CONTRACT CHANGE ORDER NO. ____
SHEET ____ OF ____

MARK	DATE	DESCRIPTIONS	BY	CH'D	CCO#
3	08/10/12	TOWER CAULKING	NV	MN	256
2	07/07/08	CAULKING	MN	NV	66
1	06/23/06	SPLICE PLATES PER ISM	MN	NV	21

SAN FRANCISCO OAKLAND BAY BRIDGE
EAST SPAN SEISMIC SAFETY PROJECT
SELF-ANCHORED SUSPENSION BRIDGE
(SUPERSTRUCTURE & TOWER)

TOWER SPLICE DETAILS NO. 8

TYPICAL TOWER SHAFT SPLICE #2

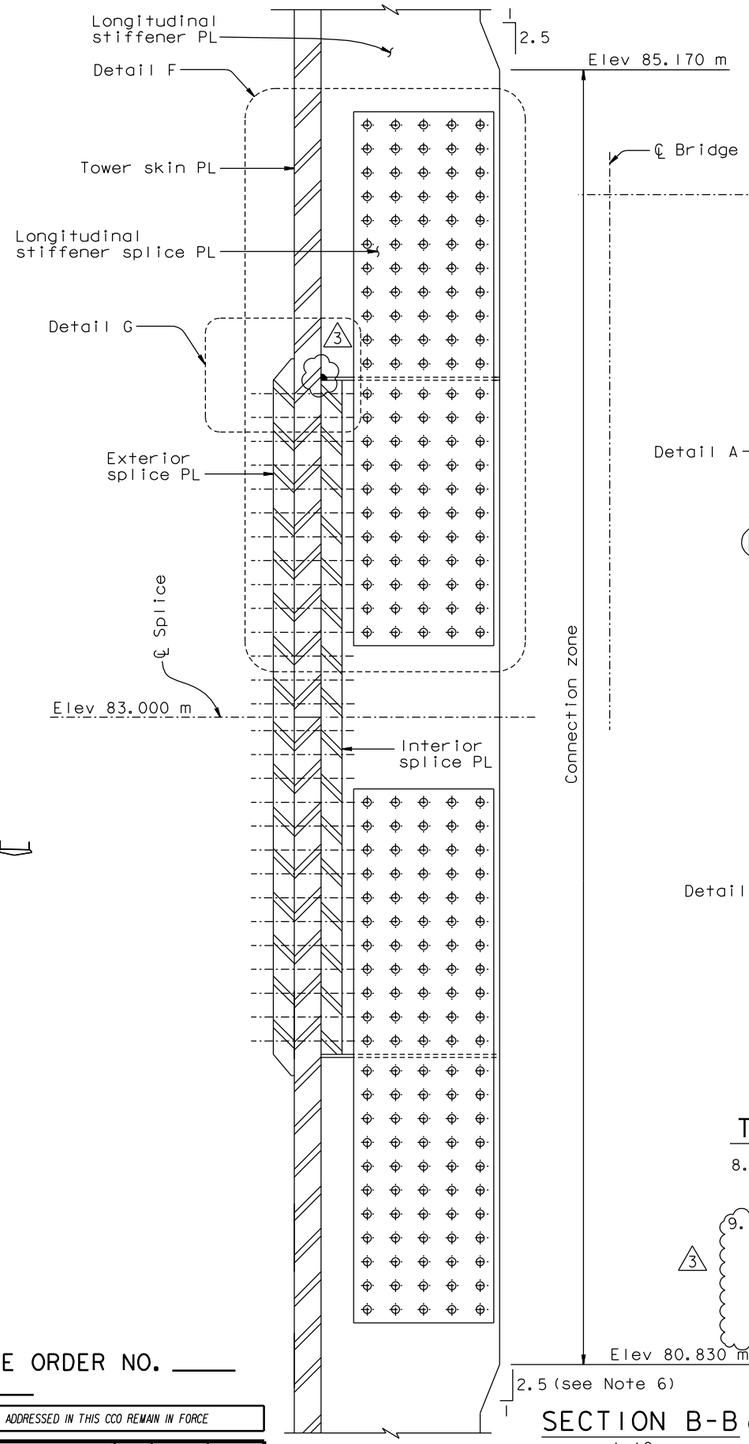
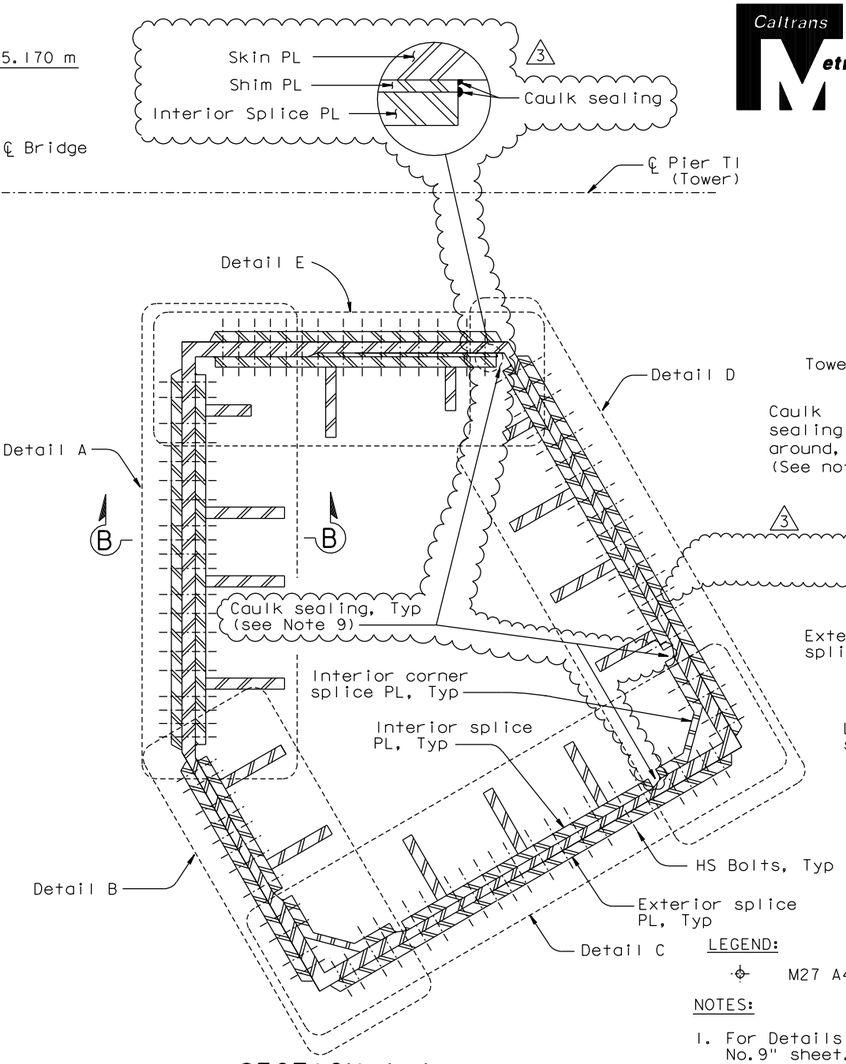
6. Stiffeners A1, E7, and D4 shall not be tapered.
7. For stiffeners A1, E2, E7, and D4, see"Tower Splice Details No.12" sheet.
8. Caulk sealing shall be applied around the perimeter (horizontal and vertical edges) of all exterior splice plates.

9. Caulk sealing shall be applied along the exposed upper horizontal edge and exposed vertical edges of all interior splice plates, interior corner splice plates, and shim plates. For upper horizontal edges, caulk sealing shall be continuous through the longitudinal stiffener plates by filling the gap between longitudinal stiffener plates and interior splice plates.
